Item ID: D407-667-105TRN

Item Name: Crosstube Turning Detail

| DART AEROSPACE LTD | Work Order: | <i>89014</i> |

| DRAWING NO. D407-667-145 | TITLE CROSSTUBE ASS'Y (407 HIGH FWD) | REV. C | DART AEROSPACE LTD ENGINEERING ORDER | | D.E.O. NO. D407-667-145-C-1 | SHEET NO. SHEET 1 OF 1 | SCALE NTS |

| CHECKED | <u>RF</u> | D407-667-145 | SHEET 1 OF 4 |

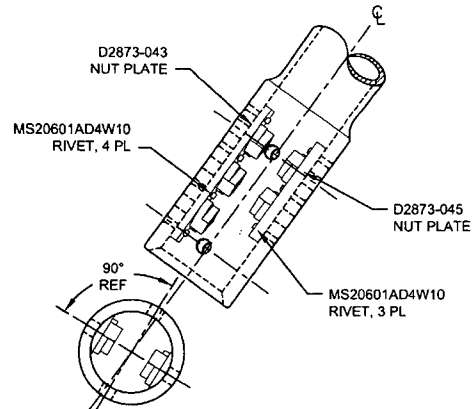
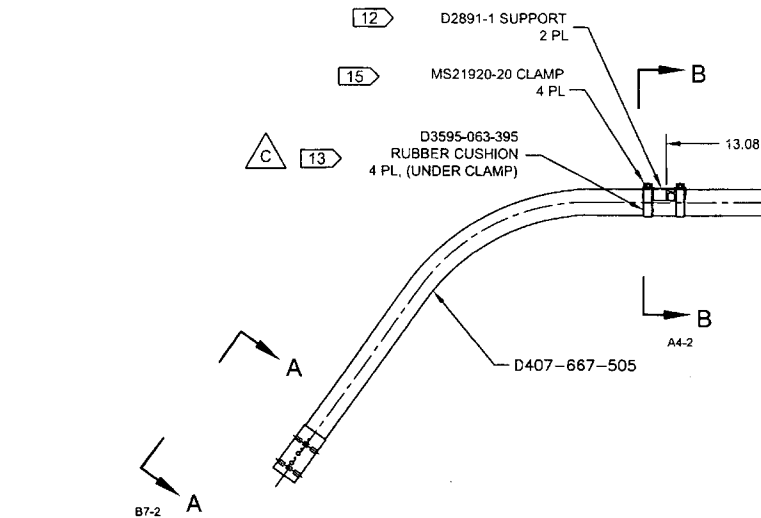
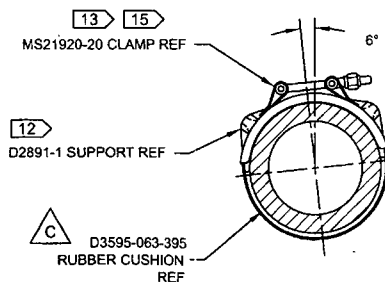
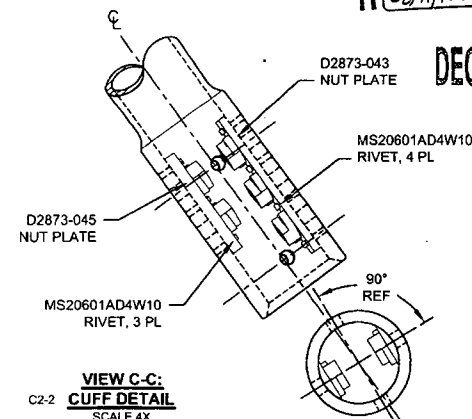
REPLACE MAGNOBOND WITH PROSEAL.

NOTE 12 & 15, SHEET 1 IS AMENDED AS FOLLOWS:

- 12) TO INSTALL D2891-1 SUPPORT: ABRAD MATING SURFACE OF SUPPORT AND CROSSTUBE WITH 180-GRIT SANDPAPER AND REMOVE RESIDUE WITH MEK (OR EQUIVALENT). APPLY A 0.04" TO 0.07" THICK LAYER OF PROSEAL 890 CLASS B-2 (OR AMS-S-8802 CLASS B-2) SEALANT TO MATING SURFACE OF SUPPORT.
- 15) TORQUE CLAMPS 80 TO 100 IN-LB. ENSURE AT LEAST 1.5 THREADS SHOWING IN SAFETY AND THAT NUT HAS NOT BOTTOMED-OUT AFTER TORQUING. **PRIOR TO PACKAGING, RE-CHECK TORQUE ON CLAMPS AFTER PROSEAL 890 SEALANT HAS CURED FOR 72 HOURS.**
